Vogtle Electric Generating Plant – Units 1 and 2
Second 10-Year Interval Inservice Inspection Program
Submittal of Relief Requests

1. RR-43, Vogtle – Units 1 and 2 Pressurizer Nozzle to Safe-End Welds
2. RR-44, Vogtle – Unit 1 Class 1 Cast Stainless Piping Butt Welds
3. RR-45, Vogtle – Units 1 and 2 Class 1 Stainless Steel Piping Butt Welds
4. RR-46, Vogtle – Unit 2 Class 2 Stainless Steel Piping Butt Welds
5. RR-47, Vogtle – Units 1 and 2 Class 1 and 2 Stainless Steel Piping Butt Welds (RI-ISI)
6. RR-48, Vogtle – Unit 2 Class 2 Ferritic Steel Piping Butt Welds (RI-ISI)
7. RR-49, Vogtle – Units 1 and 2 Reactor Pressure Vessel Shell and Bottom Head Welds
8. RR-50, Vogtle – Units 1 and 2 Class 2 Vessel Weld Examinations
9. RR-51, Vogtle – Units 1 and 2 Class 2 Residual Heat Removal Heat Exchanger Shell Welds

**SOUTHERN NUCLEAR OPERATING COMPANY
PROPOSED RELIEF REQUEST IN ACCORDANCE WITH 10 CFR 50.55a(g)(5)(iii)
RR-43 Version 1.0**

FIGURE RR-43

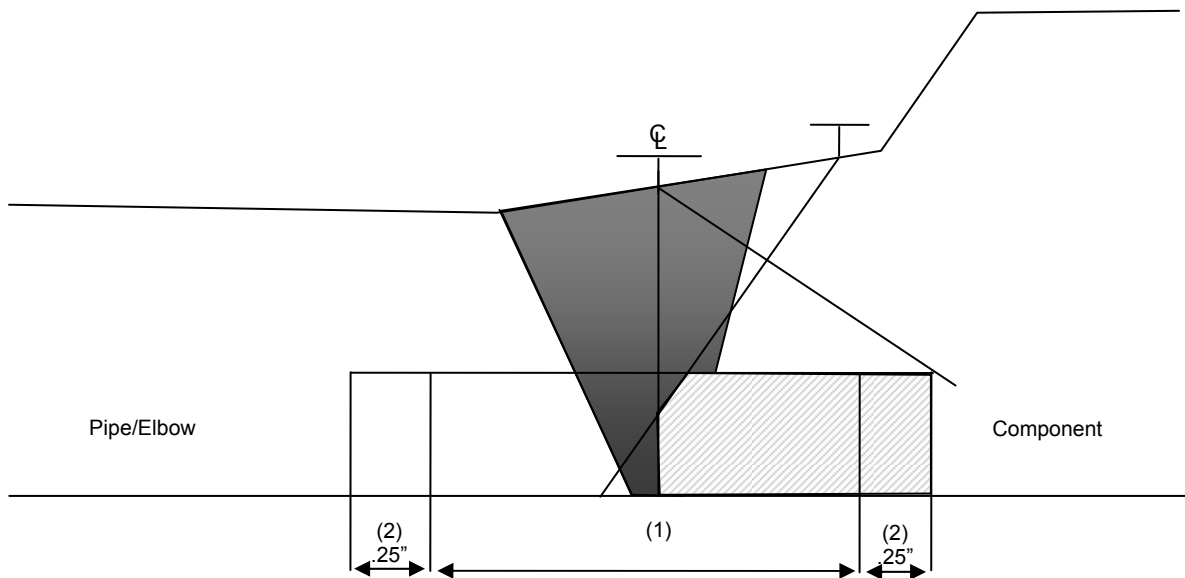
| Identification No. | Description | Limitation | Coverage | Examination Results |
|--|----------------------------------|--|-------------------|--------------------------------|
| 11201-V6-002-W17 1R9 (Fall 2000 Outage) | 6-Inch Safety Nozzle to Safe End | Pre-PDI examination. UT scans looking for circumferential cracking was 100% from the safe-end side but limited on the nozzle side due to the configuration. Limited circumferential scans on the nozzle side looking for axial cracking due to the configuration of the nozzle. See Figure RR-43 for typical picture and coverage. | 100% PT 69% UT | No Recordable Indications |
| 11201-V6-002-W18 1R9 (Fall 2000 Outage) | 6-Inch Safety Nozzle to Safe End | Pre-PDI examination. UT scans looking for circumferential cracking was 100% from the safe-end side but limited on the nozzle side due to the configuration. Limited circumferential scans on the nozzle side looking for axial cracking due to the configuration of the nozzle. See Figure RR-43 for typical picture and coverage. | 100% PT 69% UT | No Recordable Indications |
| 11201-V6-002-W19 1R9 (Fall 2000 Outage) | 6-Inch Safety Nozzle to Safe End | Pre-PDI examination. UT scans looking for circumferential cracking was 100% from the safe-end side but limited on the nozzle side due to the configuration. Limited circumferential scans on the nozzle side looking for axial cracking due to the configuration of the nozzle. See Figure RR-43 for typical picture and coverage. | 100% PT 69% UT | No Recordable Indications |
| 11201-V6-002-W20 1R9 (Fall 2000 Outage) | 6-Inch Relief Nozzle to Safe End | Pre-PDI examination. UT scans looking for circumferential cracking was 100% from the safe-end side but limited on the nozzle side due to the configuration. Limited circumferential scans on the nozzle side looking for axial cracking due to the configuration of the nozzle. See Figure RR-43 for typical picture and coverage. | 100% PT 69% UT | UT Indications due to Geometry |

| Identification No. | Description | Limitation | Coverage | Examination Results |
|--|----------------------------------|---|-------------------|---|
| 21201-V6-002-W17 2R8 (Spring 2001 Outage) | 6-Inch Safety Nozzle to Safe End | Pre-PDI examination. UT scans looking for circumferential cracking was 100% from the safe-end side but limited on the nozzle side to the configuration. Limited circumferential scans on the nozzle side due to the configuration of the nozzle. See Figure RR-43 for typical picture and coverage. | 100% PT 69% UT | No Recordable Indications |
| 21201-V6-002-W18 2R8 (Spring 2001 Outage) | 6-Inch Safety Nozzle to Safe End | Pre-PDI examination. UT scans looking for circumferential cracking was 100% from the safe-end side but limited on the nozzle side to the configuration. Limited circumferential scans on the nozzle side due to the configuration of the nozzle. See Figure RR-43 for typical picture and coverage. | 100% PT 69% UT | No Recordable Indications |
| 21201-V6-002-W19 2R8 (Spring 2001 Outage) | 6-Inch Safety Nozzle to Safe End | Pre-PDI examination. UT scans looking for circumferential cracking was 100% from the safe-end side but limited on the nozzle side to the configuration. Limited circumferential scans on the nozzle side due to the configuration of the nozzle. See Figure RR-43 for typical picture and coverage. | 100% PT 69% UT | A Code-allowable PT indication; No Recordable UT indications |
| 21201-V6-002-W20 2R8 (Spring 2001 Outage) | 6-Inch Relief Nozzle to Safe End | Pre-PDI examination. UT scans looking for circumferential cracking was 100% from the safe-end side but limited on the nozzle side to the configuration. Limited circumferential scans on the nozzle side due to the configuration of the nozzle. See Figure RR-43 for typical picture and coverage. | 100% PT 69% UT | No Recordable Indications |

| Proposed Alternative and Basis for Use: | <p>A surface examination (liquid penetrant technique) was performed on these welds. The ultrasonic examinations were performed to Appendix III and consisted of primarily a single-sided examination from the safe-end side of the weld. The ultrasonic examination was also performed from the nozzle side to the extent possible.</p> <p>Visual VT-2 examinations associated with the Class 1 leakage test were performed each refueling outage at both units. A bare metal visual (BMV) examination, in accordance with Materials Reliability Program MRP-139, was performed on the Vogtle-1 welds during the 1R12 and 1R13 outages (Spring 2005 and Fall 2006 outages, respectively) and during the Fall 2005 refueling outage (2R11). During the Spring 2008 outage (1R14) and the Spring 2007 outage (2R12), full-structural weld overlays were installed on the pressurizer nozzle to safe end welds for each Vogtle unit. In addition to mitigating these welds, the design of the full structural weld overlays allows future ultrasonic examinations to be performed with essentially no physical limitations.</p> <p>Based on the level of examination coverage obtained for the subject welds plus the Vogtle decision to install full structural weld overlays on all six pressurizer nozzles for both units, there is reasonable assurance of the structural integrity of these welds. Therefore, relief should be granted per 10 CFR 50.55a(g)(6)(i).</p> |

FIGURE RR-44

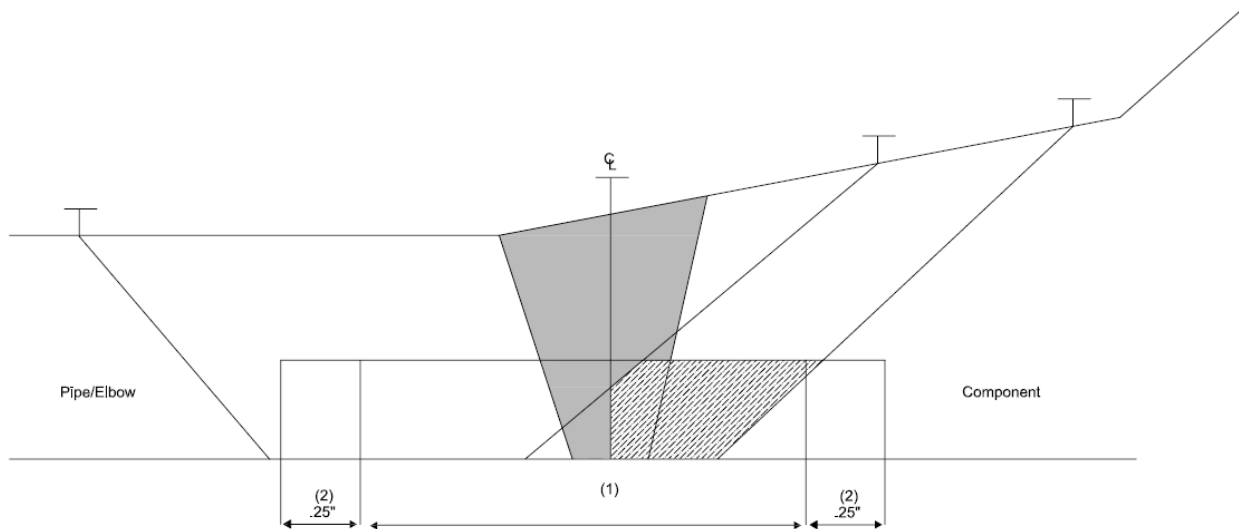
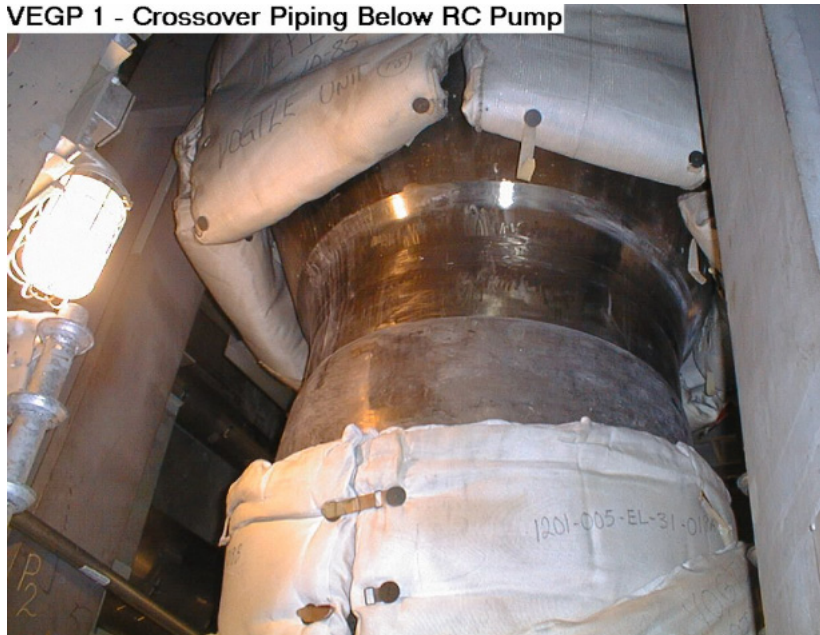
| Identification No. / Exam. History | Description | Limitation | Coverage | Examination Results |
|---|----------------------|--|-------------------|---------------------------------|
| 11201-005-8 1R8 (Spring 1999 Outage) | 31" Elbow to Nozzle | 100 % surface examination. Complete ultrasonic examination from the elbow side. Limited coverage for axial and circumferential flaws from the nozzle side due to configuration. See Figure RR-44 for typical picture and coverage. | 100% PT 90% UT | No Recordable Indications |
| 11201-009-1 1R8 (Spring 1999 Outage) | 27.5" Nozzle to Pipe | 100 % surface examination. Complete ultrasonic examination from the pipe side. Limited coverage for axial and circumferential flaws from the nozzle side due to configuration. See Figure RR-44 for typical picture and coverage. | 100% PT 75% UT | No Recordable Indications |

Proposed Alternative and Basis for Use: A surface examination (liquid penetrant technique) was performed on these welds. The ultrasonic examinations were performed to Appendix III and consisted of primarily a single-sided examination from the pipe or elbow side of the weld. The ultrasonic examination was also performed from the nozzle side to the extent possible. Based on the level of examination coverage obtained for the subject welds, if significant service-induced degradation were occurring, there is reasonable assurance that evidence of it would have been detected. In addition, VT-2 visual examinations associated with the Class 1 leakage test were performed each refueling outage. These examinations and tests provide reasonable assurance of the structural integrity of these welds. Therefore, relief should be granted per 10 CFR 50.55a(g)(6)(i).

FIGURE RR-45

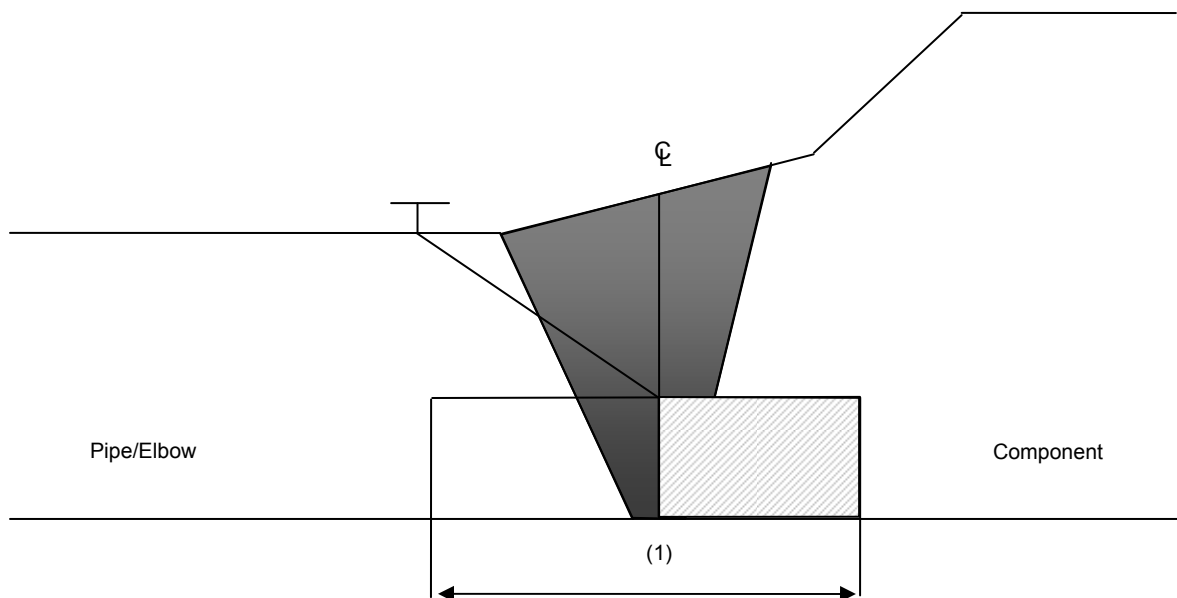
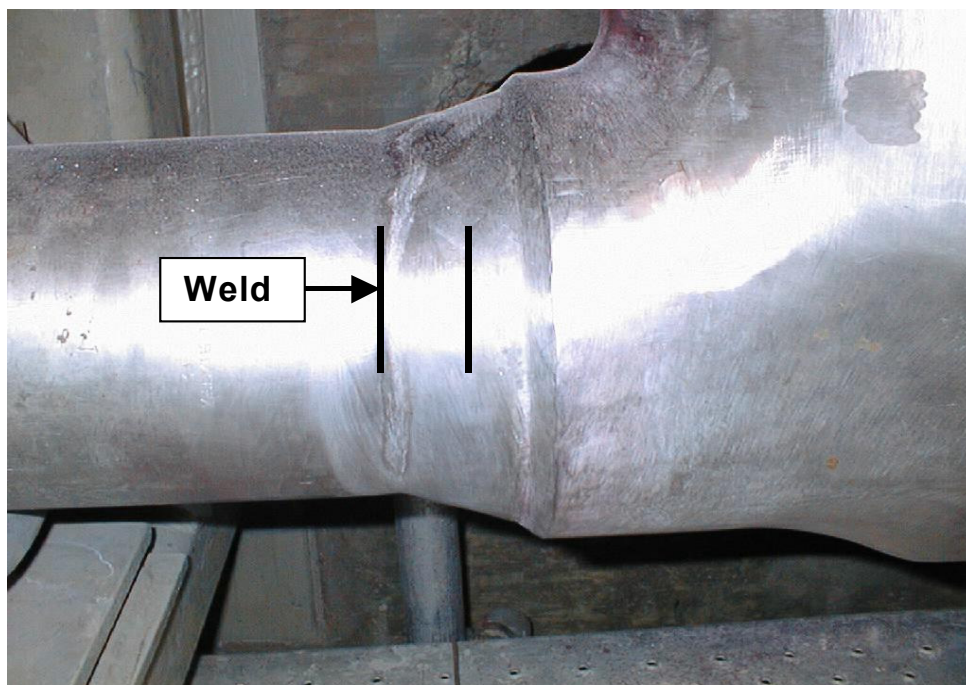
| Identification No. / Exam. History | Description | Limitation | Coverage | Examination Results |
|---|--------------------|--|-------------------|----------------------------|
| 11204-021-17 1R10 (Spring 2002 Outage) | 6" Valve to Pipe | <p>Post-PDI examination. 100% surface examination. Complete ultrasonic examination from the pipe side. No examination coverage from the valve side due to configuration. See Figure RR-45 for typical picture and coverage.</p> <p>Per 10 CFR 50.55a(b)(2)(xv)(A)(2) when examination from both sides is not possible on austenitic welds, full coverage credit from a single side may be claimed only after completing a successful single-sided Appendix VIII demonstration using flaws on the opposite side of the weld. Since PDI qualifications do not meet requirements for flaws on the opposite side of the weld, only 50% of the Code coverage can be credited.</p> | 100% PT 50% UT | No Recordable Indications |
| 21201-058-7 2R8 (Spring 2001 Outage) | 6" Elbow to Flange | <p>Post-PDI examination. 100% surface examination. Complete ultrasonic examination from the elbow side. No examination coverage from the flange side due to configuration. See Figure RR-45 for typical picture and coverage.</p> <p>Per 10 CFR 50.55a(b)(2)(xv)(A)(2) when examination from both sides is not possible on austenitic welds, full coverage credit from a single side may be claimed only after completing a successful single-sided Appendix VIII demonstration using flaws on the opposite side of the weld. Since PDI qualifications do not meet requirements for flaws on the opposite side of the weld, only 50% of the Code coverage can be credited.</p> | 100% PT 50% UT | No Recordable Indications |

| Proposed Alternative and Basis for Use: | A surface examination (liquid penetrant technique) was performed on these welds. The ultrasonic examinations were performed after Appendix VIII and consisted of a single-sided examination from the pipe or elbow side of the weld. The root of the weld was interrogated with both a 45° shear wave and a 60° |

refracted longitudinal wave looking for circumferential cracking. In addition, VT-2 visual examinations associated with the Class 1 leakage test are performed each refueling outage. These examinations and tests provide reasonable assurance of structural integrity of these welds. Therefore, relief should be granted per 10 CFR 50.55a(g)(6)(i).

FIGURE RR-46

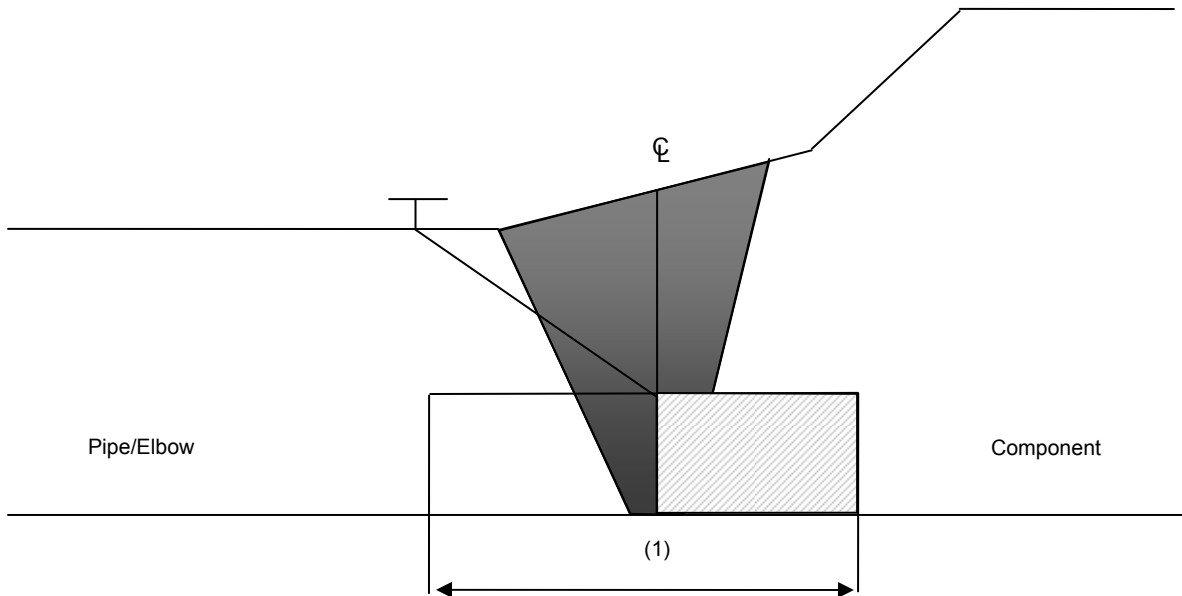
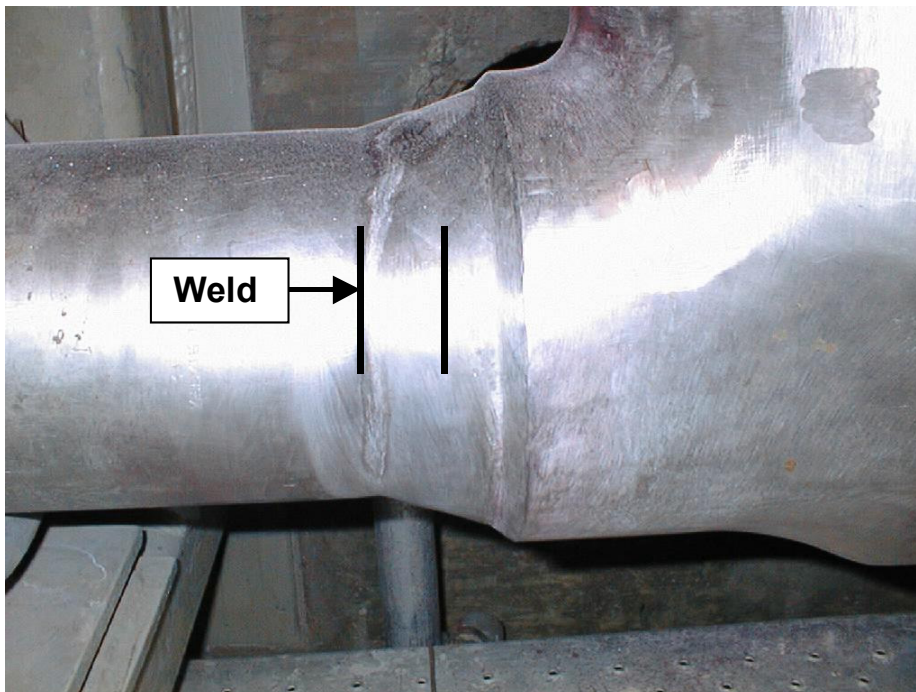
| Identification No. / Exam. History | Description | Limitation | Coverage | Examination Results |
|---|--------------------|---|-------------------|----------------------------|
| 21206-005-1 2R8 (Spring 2001 Outage) | 8" Flange to Pipe | <p>Post-PDI examination. 100% surface examination. Complete ultrasonic examination from the pipe side. No examination coverage from the flange side due to configuration. See Figure RR-46 for typical picture and coverage.</p> <p>Per 10 CFR 50.55a(b)(2)(xv)(A)(2) when examination from both sides is not possible on austenitic welds, full coverage credit from a single side may be claimed only after completing a successful single-sided Appendix VIII demonstration using flaws on the opposite side of the weld. Since PDI qualifications do not meet requirements for flaws on the opposite side of the weld, only 50% of the Code coverage can be credited.</p> | 100% PT 50% UT | No Recordable Indications |
| 21206-006-1 2R8 (Spring 2001 Outage) | 8" Flange to Pipe | <p>Post-PDI examination. 100% surface examination. Complete ultrasonic examination from the pipe side. No examination coverage from the flange side due to configuration. See Figure RR-46 for typical picture and coverage.</p> <p>Per 10 CFR 50.55a(b)(2)(xv)(A)(2) when examination from both sides is not possible on austenitic welds, full coverage credit from a single side may be claimed only after completing a successful single-sided Appendix VIII demonstration using flaws on the opposite side of the weld. Since PDI qualifications do not meet requirements for flaws on the opposite side of the weld, only 50% of the Code coverage can be credited.</p> | 100% PT 50% UT | No Recordable Indications |

| Proposed Alternative and Basis for | A surface examination (liquid penetrant technique) was performed on these welds. The ultrasonic examinations were performed after the implementation of Appendix VIII and consisted of primarily a single-sided examination from the |

- Use:** pipe side of the weld. The root of the weld was interrogated with both a 45° shear wave and a 60° refracted longitudinal wave looking for circumferential cracking. In addition, VT-2 visual examinations associated with the Class 2 leakage test are performed once every ISI period. These examinations and tests provide reasonable assurance of structural integrity of these welds. Therefore, relief should be granted per 10 CFR 50.55a(g)(6)(i).
